City of Westlake

Planning and Zoning Department – Staff Report

PETITION NUMBER: MSP-2026-02 Master Sign Plan for Cresswind Palm Beach
OWNER: KH Westlake, LLC
APPLICANT: Urban Design Studio, Inc.
ADDRESS: N/A
PCN: 77-40-43-12-13-019-0000 & 77-40-43-01-14-016-0000

DATE: 3/13/2026
APPLICATION NUMBER: MSP-2026-02 (PL202600011)
DESCRIPTION: Cresswind Palm Beach – Rear Entrance Monument
APPLICANT: Urban Design Studio
OWNER: KH Westlake LLC
REQUEST: Master Signage Plan Review
LOCATION: Westlake, FL
STAFF REVIEW: **RECOMMENDATION OF APPROVAL**

Subject Residential Pod Entry Monument Sign (Already Built)

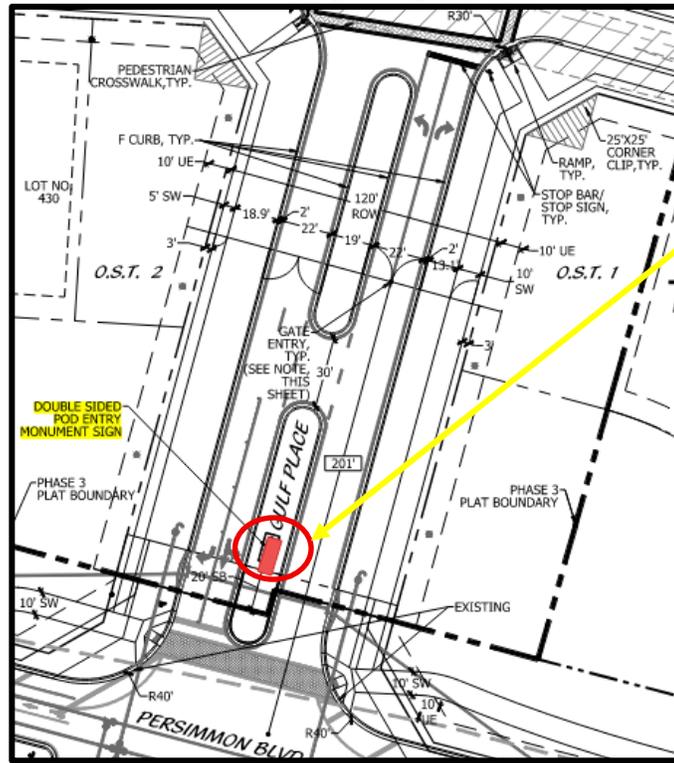
Per Chapter 113, Section 113-11, pod entry monument signs are permitted within residential developments. All such signs must comply with Figure 113-11-3, which establishes the required dimensions and architectural features.

The applicant has already constructed a monument sign located on Persimmon Boulevard East. The sign consists of white stucco, black 12" x 24" tile, and a totem feature finished with blue tile.

1. The subject sign shall be revised to include materials and colors similar to the sign located at the main entry (Town Center Pkwy).
2. Except as modified by the approved waivers, the monument sign shall comply with all applicable provisions of Chapter 113 of the City of Westlake Code of Ordinances.
3. Any sign illumination shall comply with Section 113-15 of the City sign code.
4. The sign and landscaping shall be maintained in good condition.

Proposed Residential Pod Entry Monument Sign

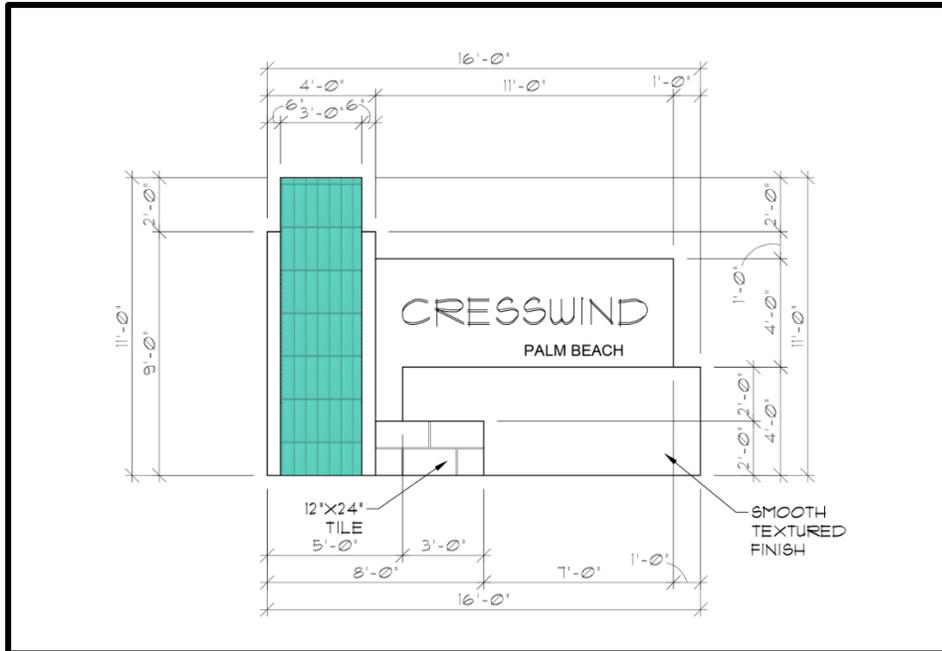
Waiver 1 – Monument Base Height: To allow a monument base height of eight (8) feet.

Chapter 113, Figure 113-11-3 establishes a maximum base height of seven (7) feet for Residential Pod Entry Monument signs. The applicant is requesting approval of a monument base height of eight (8) feet, resulting in a one-foot deviation from the standard requirement.

Chapter 113, Figure 113-11-3 establishes a maximum totem width of two feet ten inches (2'-10") for Residential Pod Entry Monument signs. The applicant is requesting approval of a three-foot (3'-0") totem width, resulting in a two-inch deviation from the code requirement.

Chapter 113, Figure 113-11-3 provides a typical freestanding design standard for Residential Pod Entry Monument signs. The proposed monument sign incorporates the signage into a larger architectural entry feature consisting of masonry walls, decorative materials, and integrated architectural elements. The applicant is therefore requesting a waiver to allow an alternative monument design integrated into the entry wall, rather than the standard freestanding monument configuration.

Staff Finding: Staff finds that the additional height is integrated into the architectural composition of the entry monument and is consistent with the scale and character of the previously approved Cresswind Palm Beach entry signage.

Staff Finding: Staff finds that this minor increase in width does not significantly alter the overall scale of the sign and remains visually compatible with the existing monument signage within the community.

Staff Finding: Staff finds that the integrated design maintains the architectural character of the Cresswind Palm Beach development and supports a cohesive and coordinated community entry feature.

A1

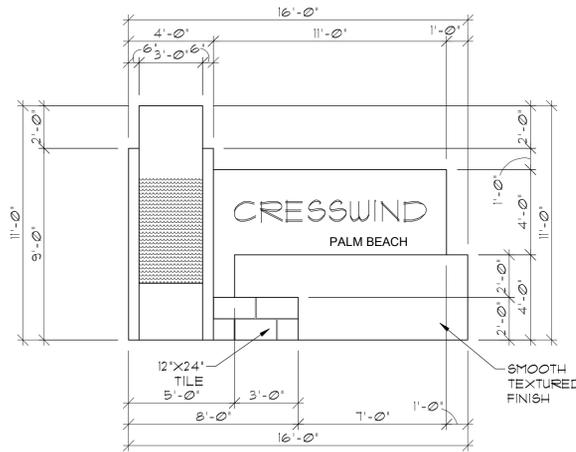
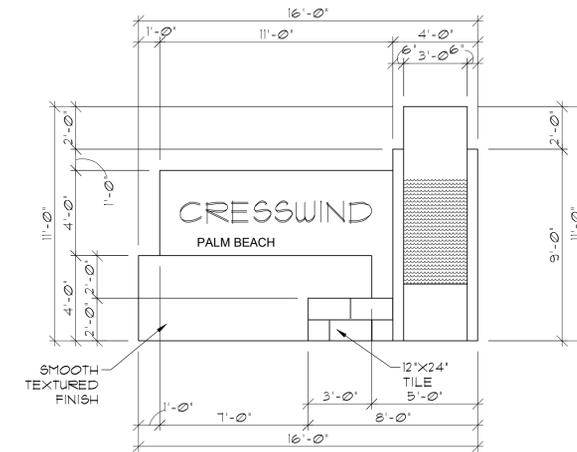
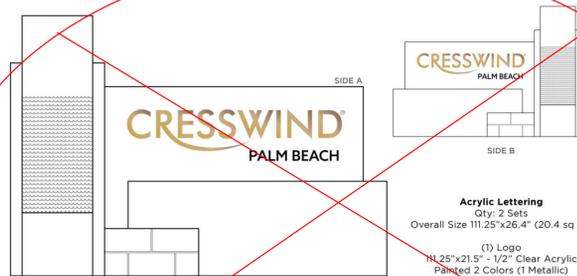
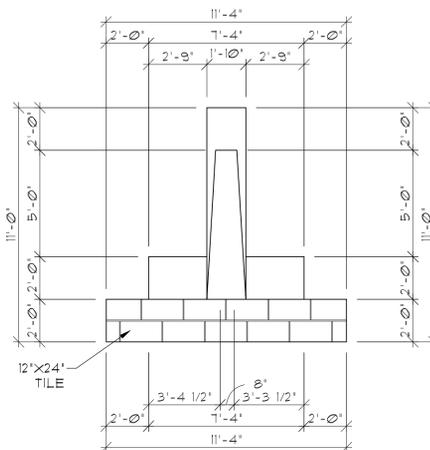
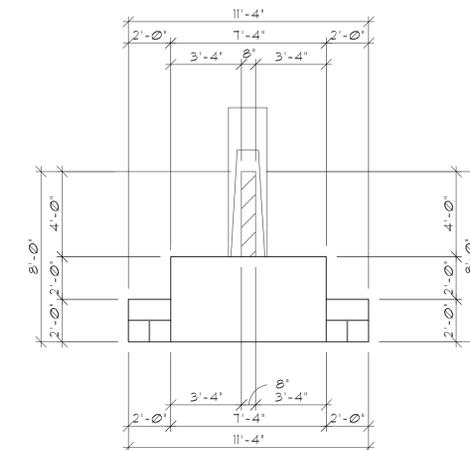
COLOR SHALL MATCH THE OTHER MONUMENT SIGN IN THE CITY

NOT APPROVED

A1

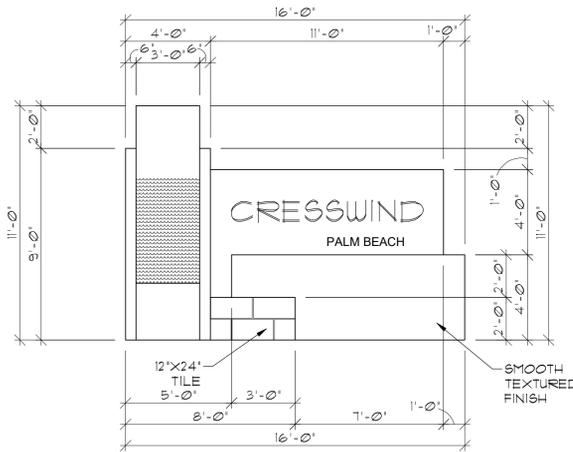
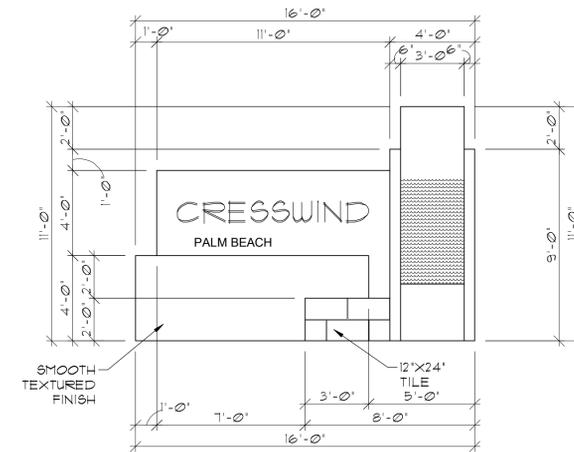
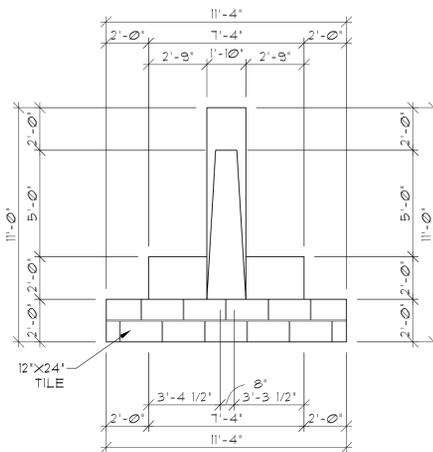
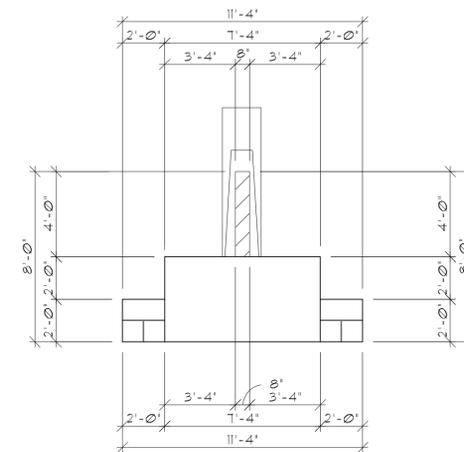
COLOR SHALL MATCH THE OTHER MONUMENT SIGN IN THE CITY

NOT APPROVED
